05.07.2014 DESIGN REVIEW: RECOMMENDATION PACKAGE

1622 E YESLER WAY / DPD PROJECT # 3015183

**ADJACENT PROPERTY ANALYSIS**

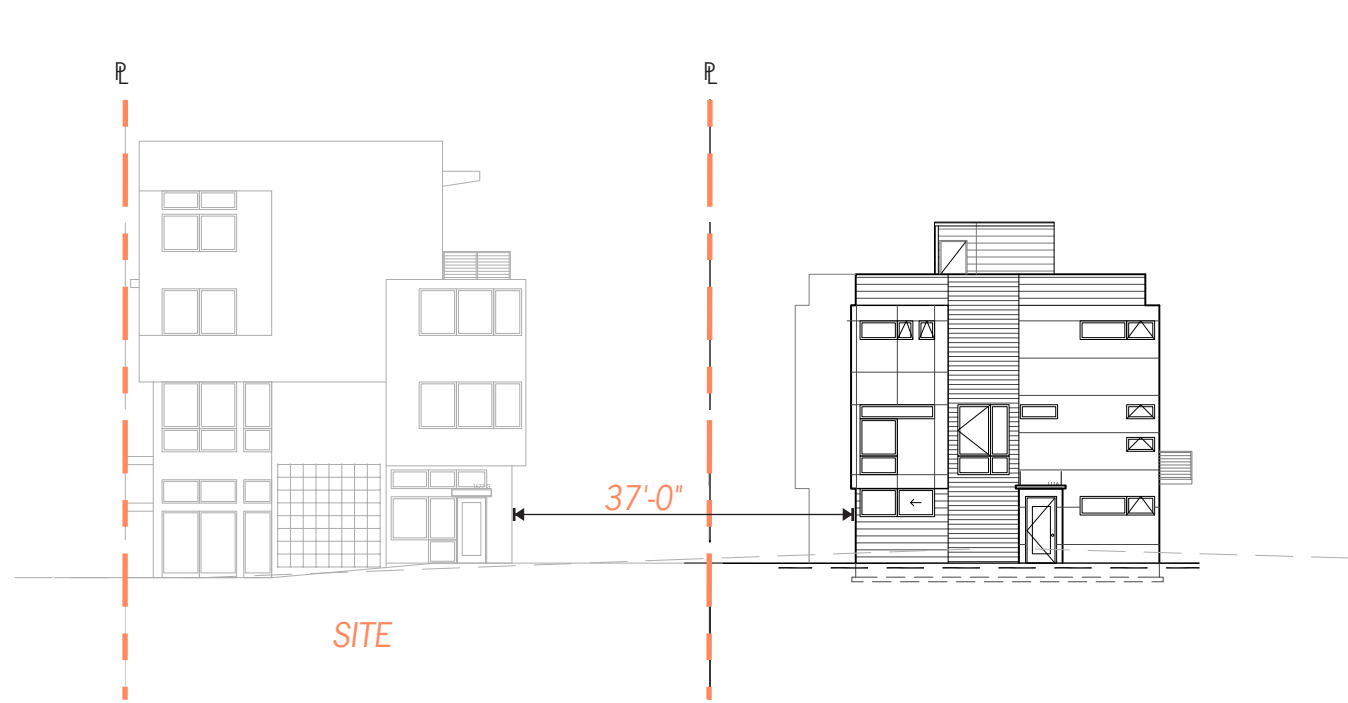
**EDG Report:**

At the Recommendation meeting, the Board expects to view in both plan and elevation views the proposal, existing residential property to the west, and the new residential proposal to the north. The applicant should also provide similar information to demonstrate how the adjacent facades and proposed fenestration lines up with existing/proposed residential unit windows to the west and to the north of the subject site. (C-1, C-2)

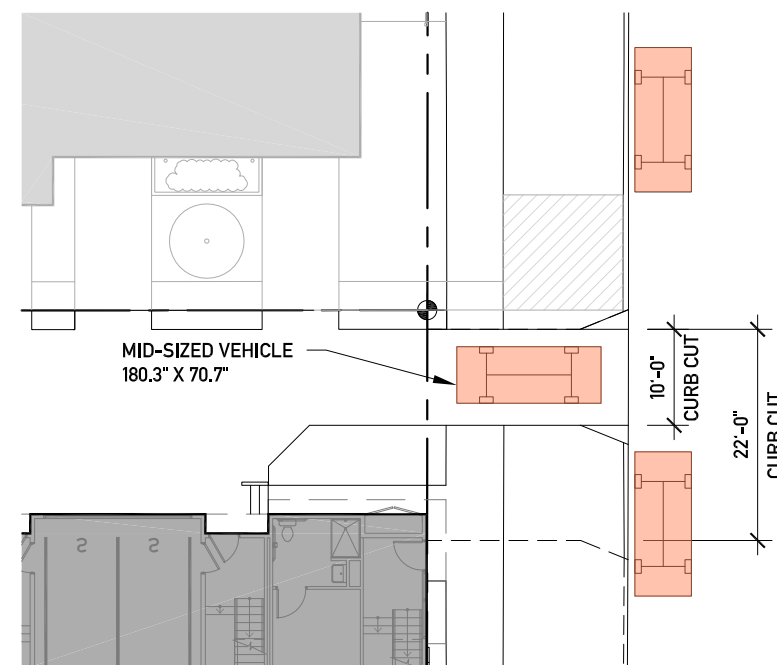
SMC

23.54.030.F.2.b.2

REQUIREMENT

The minimum width of curb cuts for two-way traffic with non-residential uses shall be 22 feet and the maximum shall be 25 feet.

DEPARTURE

10'-0" curb cut

JUSTIFICATION

Per EDG design review board recommendation, a smaller curb cut will provide more street parking and lessen the impact on pedestrians in the neighborhood, while allowing more space for landscaping, creating a "park-like" atmosphere. The reduced curb cut size is also characteristic of the curb cuts along 17th Avenue which are typically for residential use.

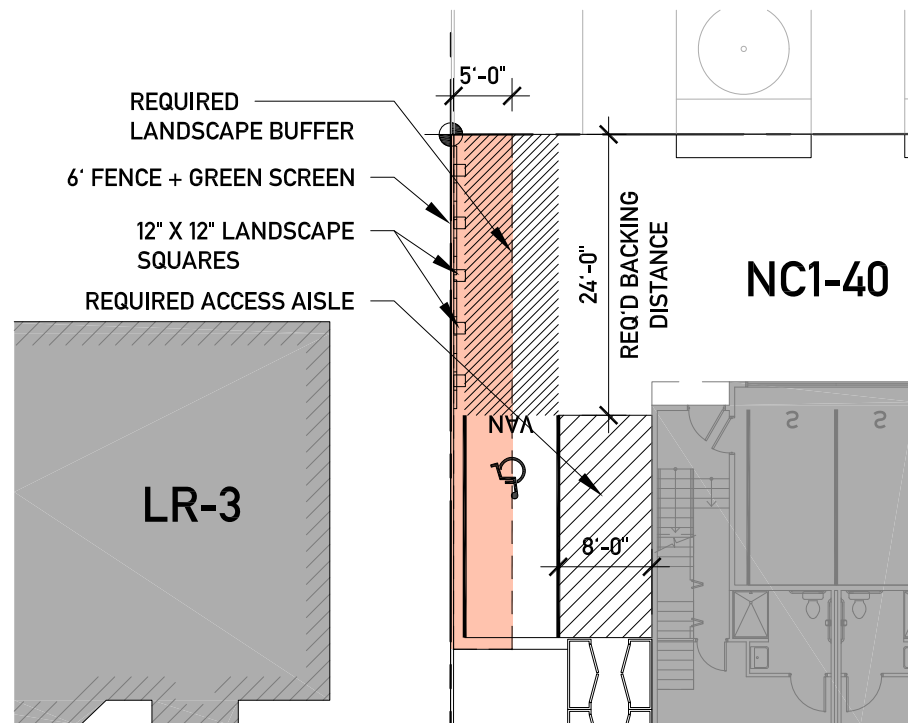
SMC  
23.47A.016.D.1.c.2

REQUIREMENT

Surface parking abutting a residential zone must have a 6' high screening and 5' deep planting area

DEPARTURE

Use of green screen in lieu of required planting area

JUSTIFICATION

Per the Board's request, we removed parking from the corner unit to enlarge the commercial area at the corner of 17th Avenue and East Yesler Way. The 5' landscape buffer would conflict with the required backing distance of the accessible van stall. Small planting squares (12"x12") are incorporated to be utilized with a green screen mounted on the 6' high fence. This feature will enhance the project, providing some greenery on the fence and making the driveway more "park-like".
